RE: Safety Recall Campaign
Turtle Top Recall Campaign Number: RCN-040312
National Highway Safety Administration Assigned Recall Number: 04V-149

**AD-100 Electric Door Motor Assembly
Emergency Release Handle Change Instructions
RCN-040312 (NHTSA Assigned Recall # 04V-149)**

BULLETIN NO.
TSB-040312

Photo 4

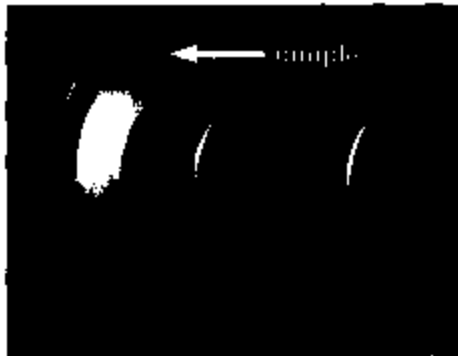
4. Before installing new handle note very small "dimple" on the handle assembly. This dimple aligns the handle for mounting. (Photo 4)
5. Place the mounting hole on the handle assembly that is nearest to the dimple in the highest position. Install new bolts included in the kit to mount the handle assembly to the door motor assembly. Hand tighten mounting bolts snug. (Photo 5)
6. Change the EMERGENCY RELEASE instruction sign with the sign included in the kit. This is important as the new sign instructs to turn the lever and the old sign instructed to pull the lever. (Photo 6)
